SERVICE BULLETIN AMATEUR RADIO

| SUBJECT TA7201P SUBSTITUTION PARTS KIT | DATE 07/20/89 |

The Toshiba TA7201P audio amplifier (Q3) used in the TS-820(S) and R-820 is no longer available. The part has been replaced with a kit (PART # W05-0257-00). This service bulletin will provide the correct installation procedures for replacing a defective TA7201P with the new kit.

FIGURE 1

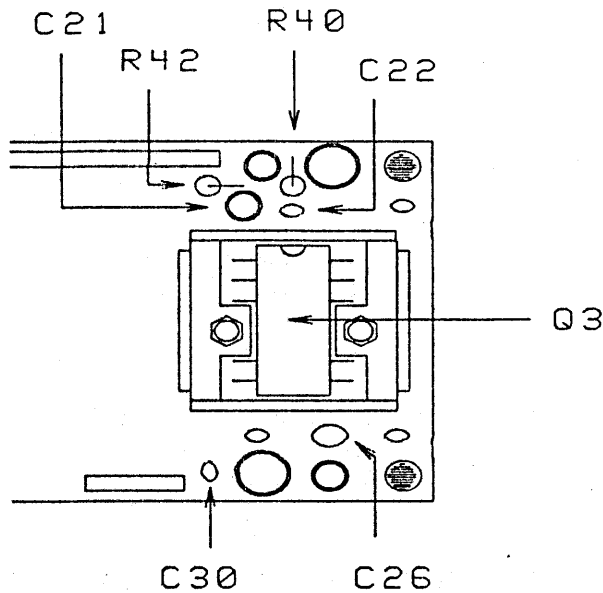
4. Remove the two nuts that secure the heat sink to the audio amplifier (Q3) and then remove the heat sink. FIGURE 1
5. Desolder and remove Q3, C21, C22, C26, C33, R40, R42, and R47 from the AF AVR board. C33 and R47 are mounted on the foil side of the board, but may not be installed on some models. FIGURE 1 & 2

6. Using the parts from the kit, install a 22uF capacitor in the C21 position, a 0.068uF capacitor (labeled 683K) in the C22 position, a 3.9 ohm resistor in the R40 position, and a 470 ohm resistor in the R42 position. FIGURE 1

7. Solder a 0.1uF capacitor (labeled 104K) in parallel with C30. Mount the part on the foil side of the AF AVR board. FIGURE 1
8. Remove the two nuts from the heat sink mounting screws. FIGURE 3

FIGURE 3

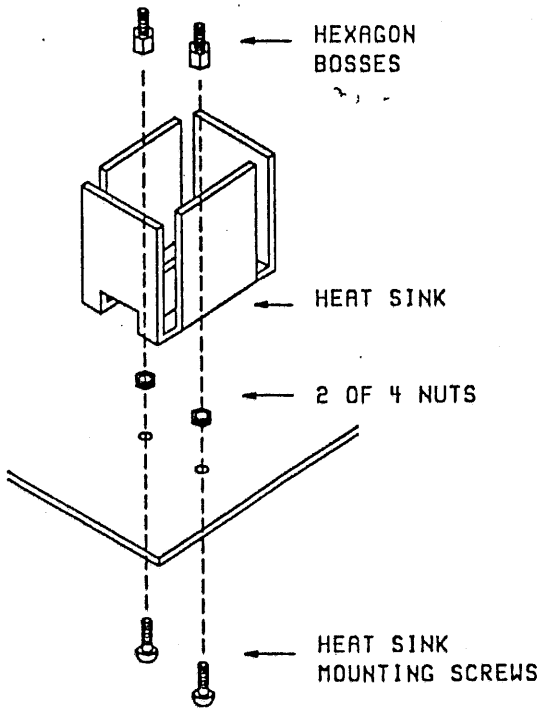
9. Replace the mounting screws with the ones in the kit. If the original screws have been soldered to the board, remove the excess solder and while the screws are still hot, turn the board upside down to allow the screws to fall onto the working surface. FIGURE 3

10. Secure the new mounting screws with the two nuts that were removed in step 8. FIGURE 3
11. Install the heat sink and secure it with the two hexagon bosses from the kit. FIGURE 3

FIGURE 4

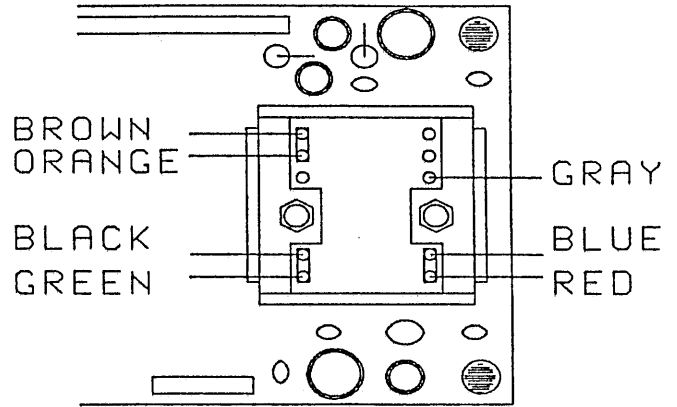
12. Insert the wires from the new audio amplifier circuit board as shown in the diagram. Make sure the pins are firmly seated and then solder them into place. FIGURE 4
13. Apply a thin layer of silicon grease to the back of the audio chip.
14. Insert the circuit board into the heat sink and secure it with the two nuts that were removed in step 4. Avoid pinching the wires between the board and the bosses as well as the board and the heat sink.
15. Attach the heat sink spring from the kit over the chip. FIGURE 5
16. Assemble the transceiver by reversing steps 1 - 3.
